## M<sup>C</sup>LAREN TRAFFIC ENGINEERING

23rd March 2020

Reference: 190746.04FB

### PEER REVIEW OF THE TRAFFIC AND PARKING ASSESSMENT OF THE PROPOSED MIXED USE DEVELOPMENT AT 187 - 203 PEATS FERRY ROAD

Figure 2.8 : Vehicle right-turning violation at intersection of Peats Ferry Road and Dural Street

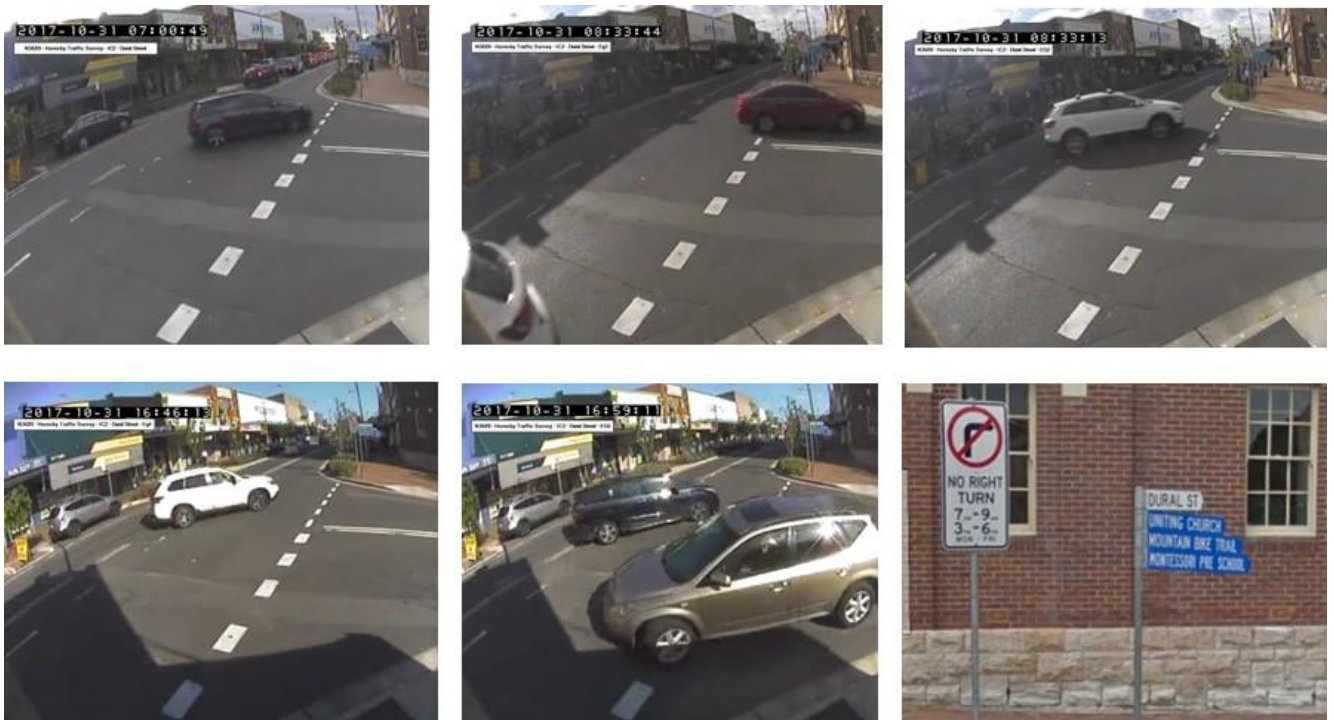
**MTE Response:** Commentary has been added to Section 2.8 of the JTP report in relation to the number of vehicles turning right into Dural Street from Peats Ferry Road outside of turn ban restriction. The JTP Report does not provide an assessment of the development when the right turn movement is allowable. Although considering 100 vehicles currently undertake this movement outside turn restrictions, it is expected that further delays due to additional right turn movements would occur to vehicles travelling southbound along Peats Ferry Road. It is relevant to note that the assessed assumed Saturday period shows 135 vehicles turning right into Dural Street with a 95th percentile queue of 27m, which does not queue back to the intersection of Coronation Street / Peats Ferry Road. Vehicles attempting to turn right into Dural Street from Peats Ferry Road may impact the capacity of the signalised intersection of Coronation Street / Peats Ferry Road, although based upon the provided SIDRA, the only capacity constraint at the intersection of Coronation Street / Peats Ferry Road is due to vehicles overflowing into the through lane for those vehicles turning right into Coronation Street from Peats Ferry Road (south). Whilst SIDRA reports no capacity reduction, it is likely to occur in practice.

Figure 3.7: Swept Paths for B1 (B99 and B85 vehicles)

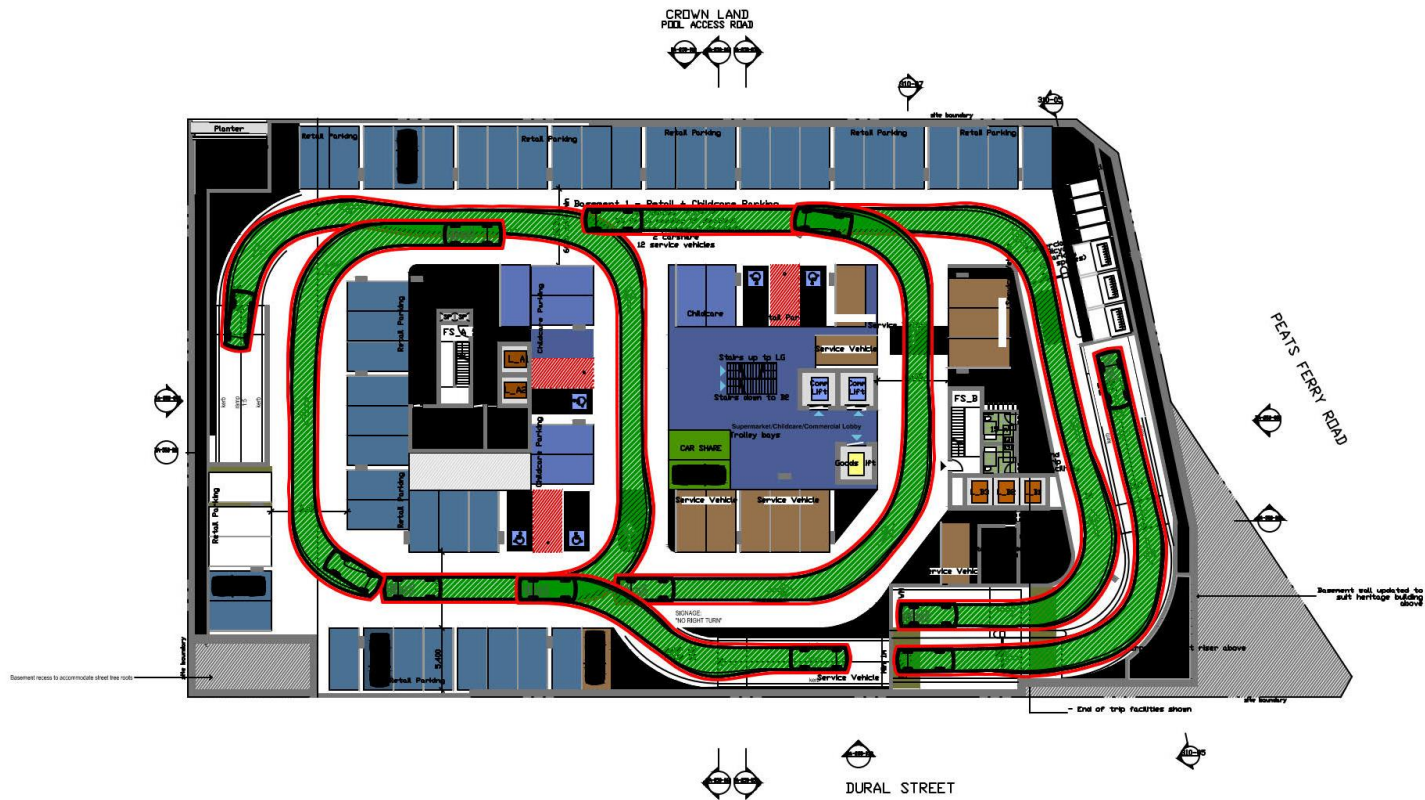
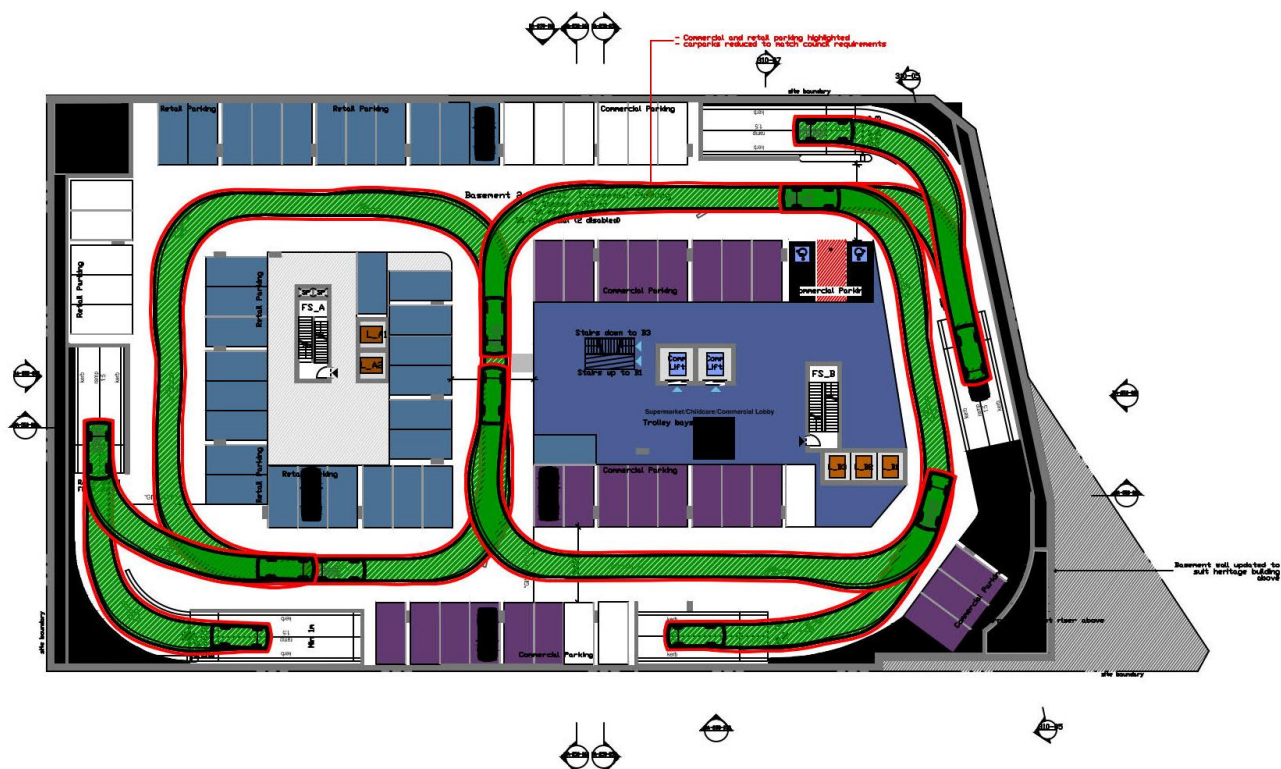
*The swept paths in Basement 1 are shown to travel over car parking spaces and have no vehicle clearances. This applies to all basement levels (Figure 3.7 to Figure 3.9);*

**MTE Response:** As mentioned previously MTE has been providing design advice for the layout of the basement car parking areas and as such the concerns raised previously in relation to the driveway access, car park circulation areas are now resolved. The design achieves separate entry and exit driveways, separated by a small island for pedestrians.

Swept paths within the report show that the internal layout is successful for vehicular circulation along all ramps and circulation aisles.

Figure 3.11 : Right turn path from Peats Ferry Road to Dural Street (with curb adjustment)

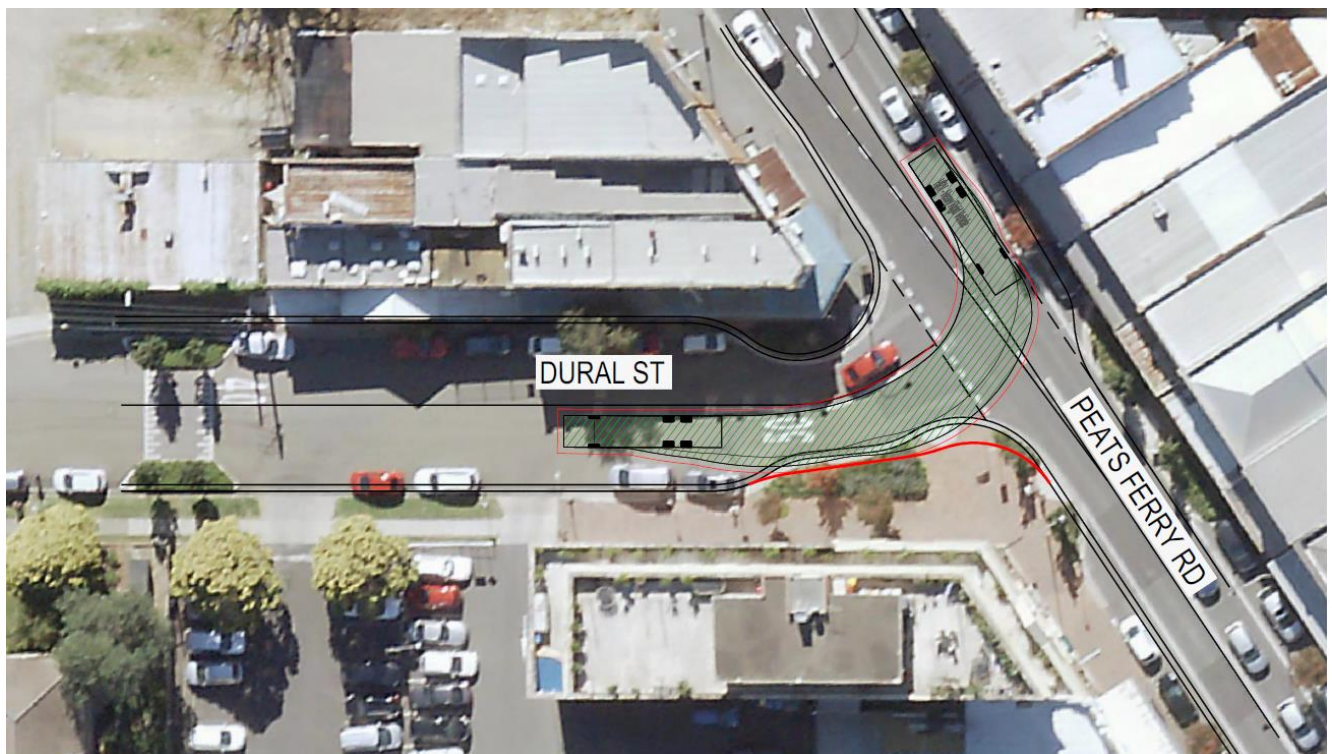
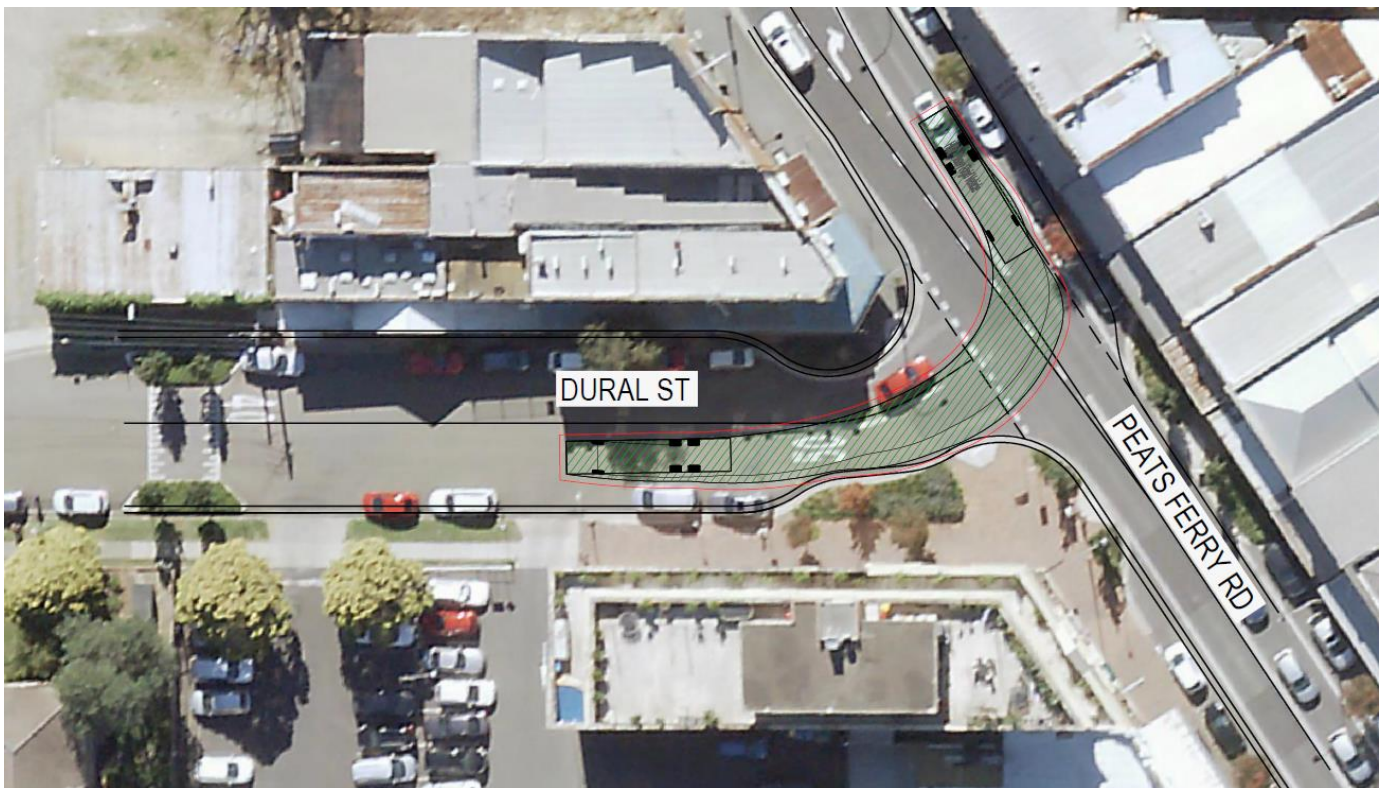
- Modifications are required to the kerb on the southern corner of Dural Street / Peats Ferry Road to allow a 12.5m length heavy rigid vehicle (HRV) to turn into Dural Street without travelling over the centreline of the road;
- A 12.5m HRV cannot turn left onto Peats Ferry Road from William Street without encroaching onto the other side of the road;
- A 12.5m HRV can turn right onto Peats Ferry Road from William Street;
- A 12.5m HRV cannot turn right onto William Street from Frederick Street without encroaching onto the other side of the road;
- A 12.5m HRV cannot turn left onto Frederick street from Dural Street without travelling on the wrong side of the road along Dural Street and in any event encroaches onto the other side of the road along Frederick Street.

Figure 4.5: Outbound Trip Distribution

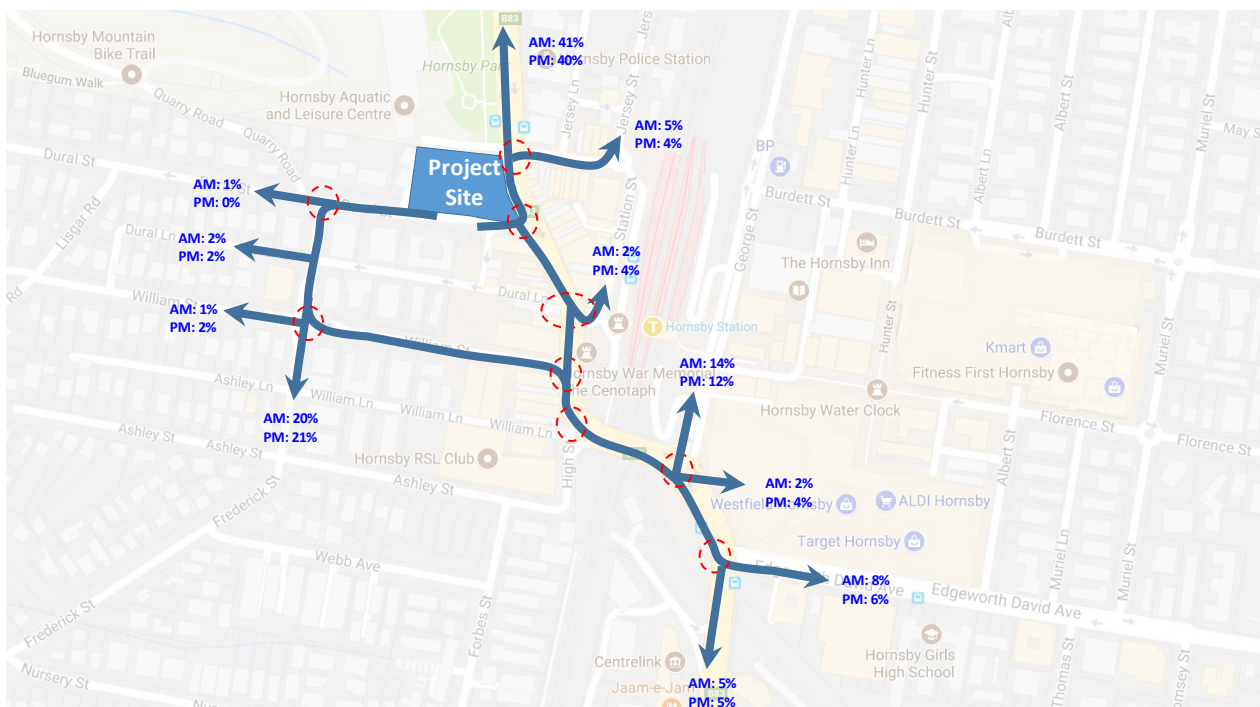
**MTE Response:** The JTP Report still states that no vehicles will turn right onto Peats Ferry Road from Dural Street, but has completed SIDRA based upon the provision of right turns out of Dural Street onto Peats Ferry Road. This is the preferred route that needs to be assessed considering there are no current turn restrictions. Based upon Figure 4.5 of the JTP report approximately 31% of

all vehicle have the potential to travel along Peats Ferry Road, based upon the outbound volume of 136 vehicle trips during the PM peak hour period, this corresponds to 42 right turn movements (not including existing traffic flow). The existing traffic flow was some 7 vehicle movements resulting in a total of 49 right turn movements, the assessed vehicle flow based upon Figure 4.7 of the JTP Report is 32 in the PM peak hour period. Notwithstanding this, a sensitivity test was undertaken for the right turn out of Dural Street with 44 vehicle movements turning right with the resultant vehicle queue being 27m. This indicates that the vehicle driveway will not be blocked by right turning vehicles during the PM peak hour period and is supported.
